CONCEPT DEVELOPMENT PLAN
BOONE COUNTY PLANNING COMMISSION

- 2. Name of Project Meijer, Inc. Fueling Facility and Convenience Store
3. Location of Project 4990 Houston Road, Florence, Kentucky
4. Total Acreage of Site Less than one acre

Request of **Meijer, Inc. (owner)** for a Change in Concept Development Plan in an Office Two/Commercial Two/Planned Development (O-2/C-2/PD) zone at 4990 Houston Road, Florence, Kentucky. The request is for a change in an approved Concept Development Plan to permit a freestanding convenience store with retail fuel sales.

MEIJER 151
 GAS & CONVENIENCE STORE
 FLORENCE, KENTUCKY

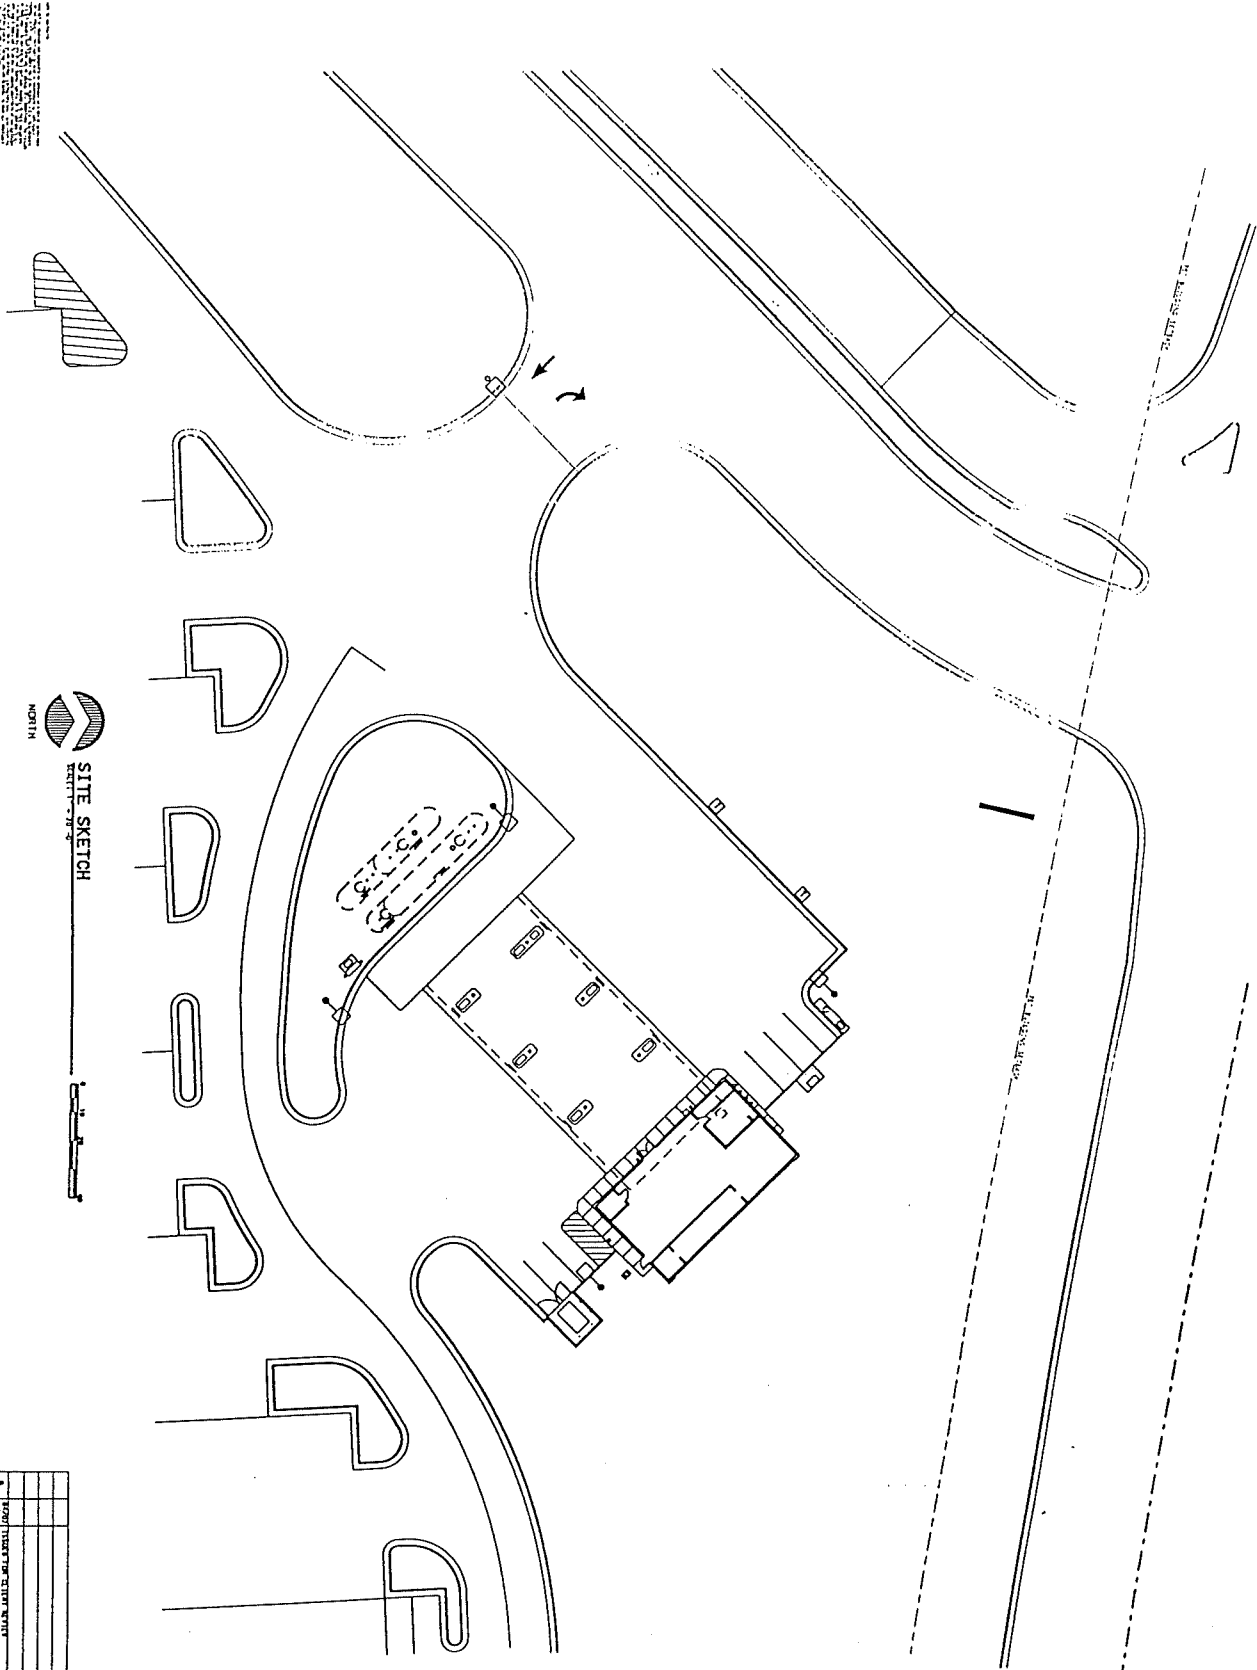
7. Architecture: As noted above, the design of the convenience store building itself generally relates to the existing Meijer building, however, window openings which are proportionate to their respective facades should be provided on the street facades to provide a favorable "street presence," unless heavy landscaping is provided between the building and the adjoining streets as suggested above. Contrary to the design of the building, the size of the canopy is very imposing and the design doesn't integrate with (or even correlate to) the convenience store building or other structures in the area. There are methods for adding design elements to the canopy that would help overcome the aesthetic design issues, although, adding design elements can not tangibly detract from the large size of the canopy.

9. Signage: The proposal involves the installation of new canopy signs and a change of copy on the Meijer monument style sign at the Houston/Spiral intersection. The "reused" monument style sign is larger than is normally allowed for an outlot use (existing sign is 99 square feet, an outlot is permitted 24 square feet), although an outlot is permitted its own monument sign under normal circumstances. Thus, the Commission will need consider the fact that although the reused sign is larger than normally permitted for an outlot, the outlot could otherwise

4. Staff has the following general issues regarding the proposal.
 - A. The "Blue Rhino Propane" shown on the landscape plan needs to be explained. If this is some sort of propane dispenser (such as the kerosene dispenser shown on the plan) or rack for propane containers, the Commission will need to evaluate the appropriateness of outdoor propane and kerosene sales/storage, much like the outdoor storage/display of seasonal merchandise discussed previously.

- B. Based on the requirements of Article 33 of the Boone County Zoning Regulations, at least sixteen parking spaces must be provided for the project. A total of seven parking spaces are shown on the Concept Development Plan.

Mr. Fossett asked Mr. Kinsel to address Staff's comment that there were not enough parking spaces. Mr. Kinsel stated that 16 spaces are required and they are only showing seven -- but there are 12 fueling stations that would act as parking spaces. He stated that the majority of the guests who use the convenience store do so after they fill up their car at the pump. He stated that there are 19 parking spaces within the site and, if needed, they also have all of the parking on the Meijer lot.

Mr. Fossett asked Mr. Kinsel to comment regarding the sidewalk and the bike rack. Mr. Kinsel stated that they have no problem with a sidewalk to the roadway and a bike rack at the facility.

FIGURE 2
SITE PLAN

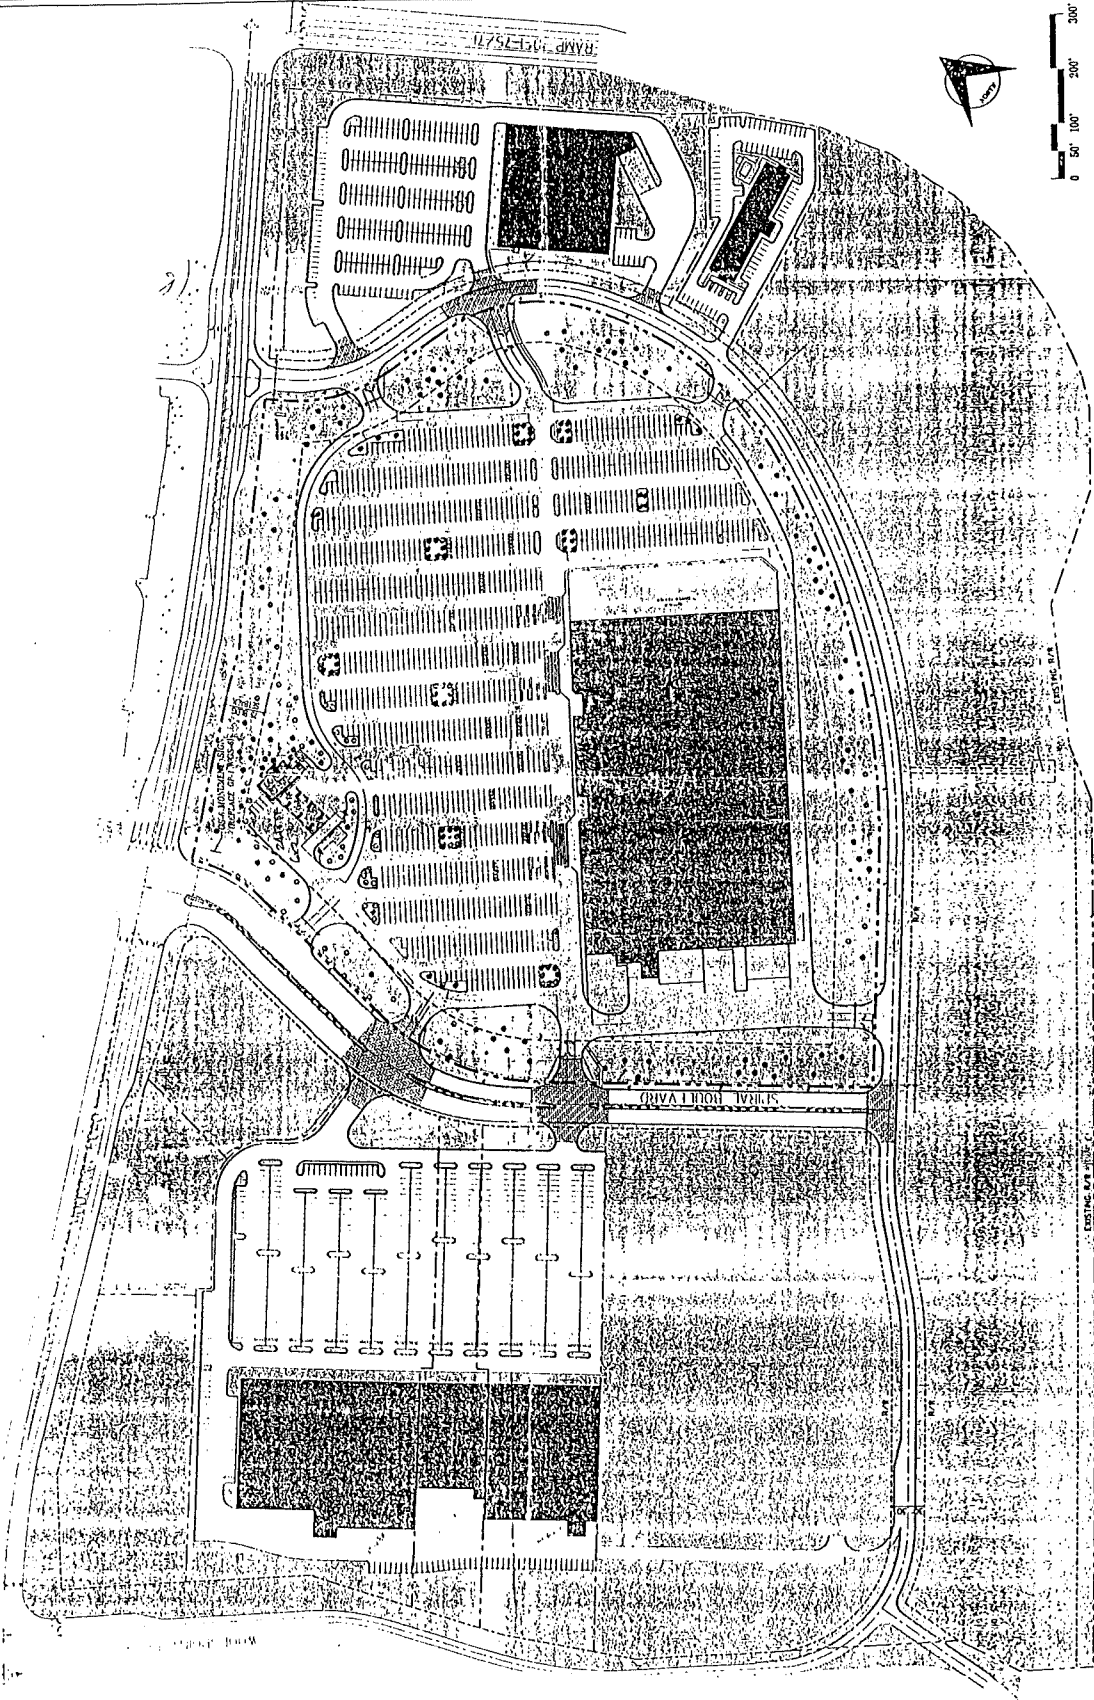
The current Site Plan for the Meijer gasoline/convenience market proposes a right-in/right-out driveway from the adjacent parking lot drive to/from Spiral Boulevard. This driveway is existing, located approximately 200 feet south of Houston Road, and currently operates as a full-access driveway. The Site Plan proposes closure of the median curb cut at this first driveway on Spiral Boulevard to eliminate left turn movements in and out of this driveway. These left turning movements would then utilize the full movement driveway located approximately 250 feet south of the proposed right-in/right-out driveway, alleviating any threat of left turning traffic stacking into the signalized intersection of Houston Road and Spiral Boulevard.

At the present time, a conflict often occurs at this first drive due to the southbound dual left-turn movements from the signalized intersection at Houston Road. A weaving or lane change often occurs, which delays the traffic flow on Spiral Boulevard and affects the intersection operations.

The elimination of the median access to Lot Drive #1 is an improvement to southbound Spiral Boulevard. It improves the situation caused by traffic changing lanes in order to turn left into Lot Drive #1. By closing the median at Lot Drive #1, drivers have more time and distance to maneuver should they decide they need to change lanes in order to turn into Meijer.
